Technical Service Bulletin: TSB170095

New Blowby Pressure Sensor

New Blowby Pressure Sensor, Part Number 5461522.

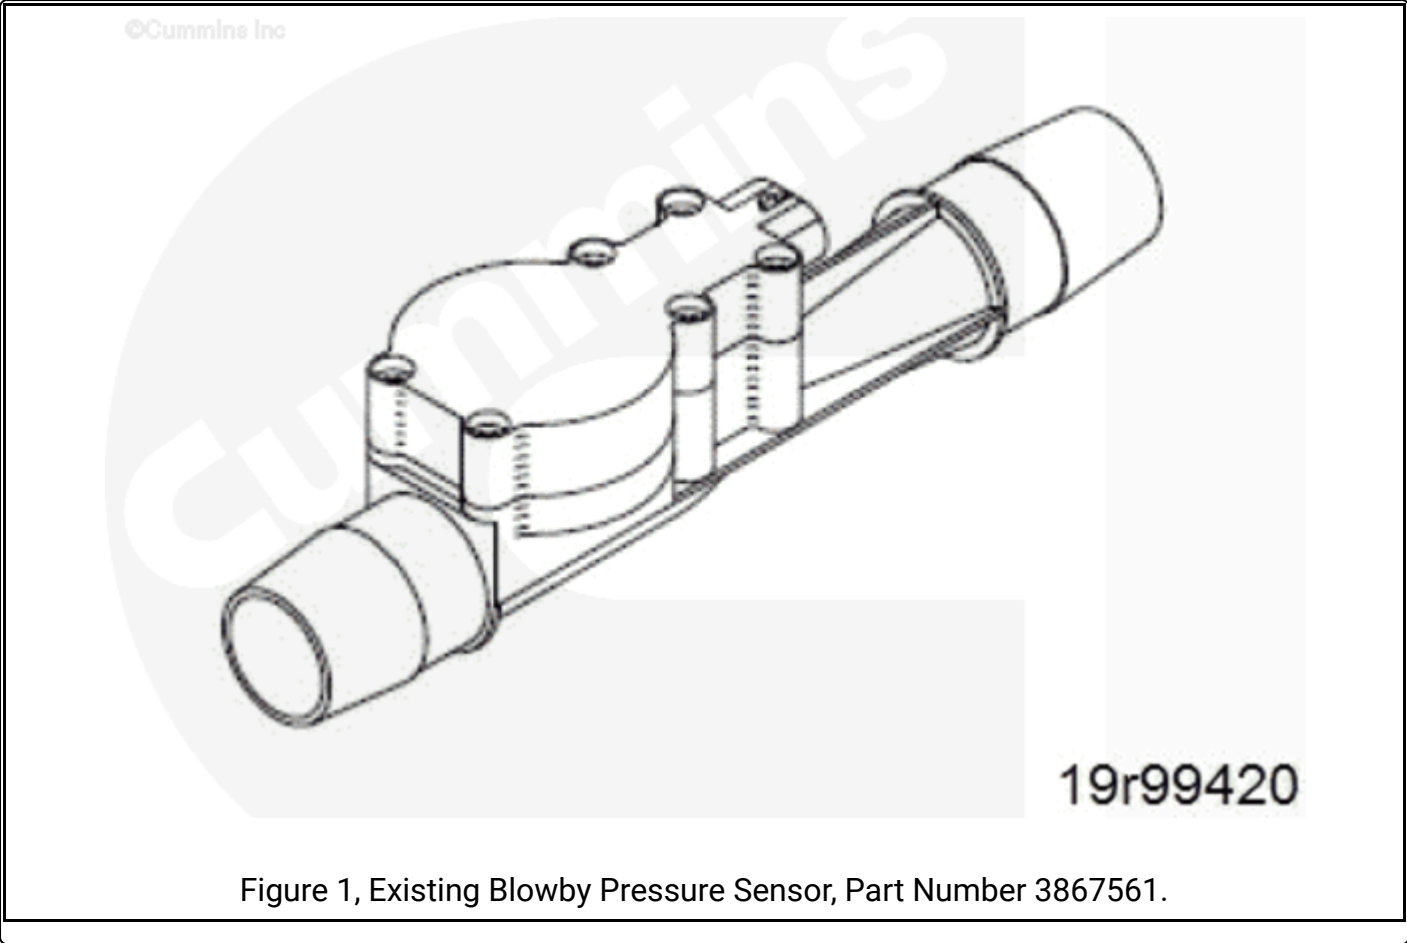
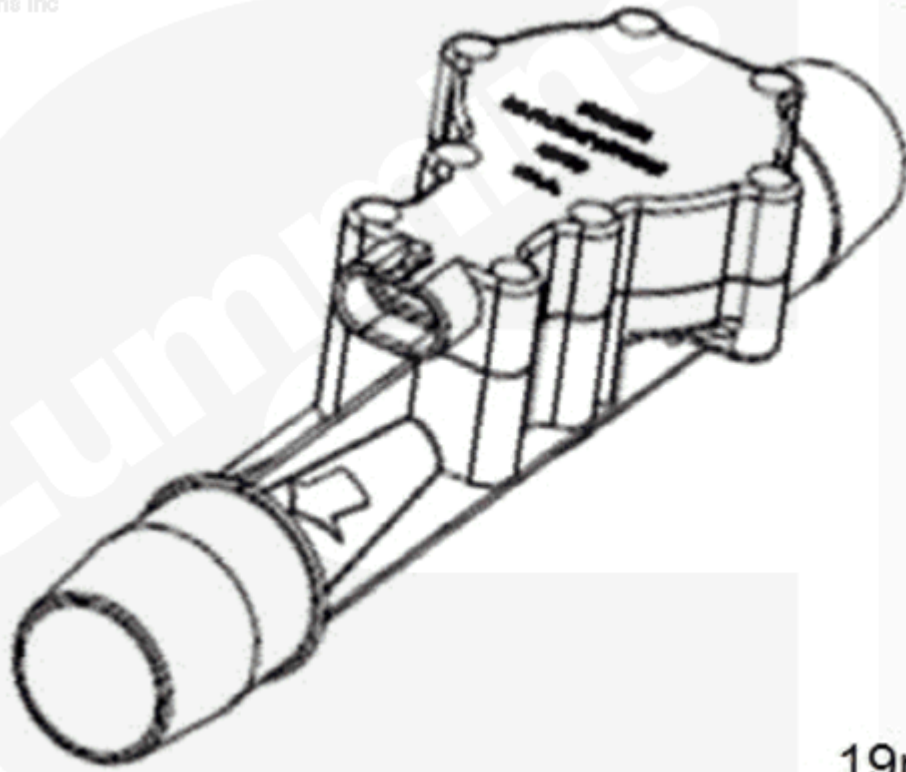
- A new blowby pressure sensor is available. New blowby pressure sensor has a total of eight capscrews on upper housing of sensor body.
- Existing blowby pressure sensor has six capscrews on upper housing of sensor body.

Moisture or dirt ingress into sensor internals can occur as existing blowby pressure sensor has insufficient clamping of internal environmental and bezel seals. New design prevents loss of compression sealing on blowby pressure sensor upper housing.
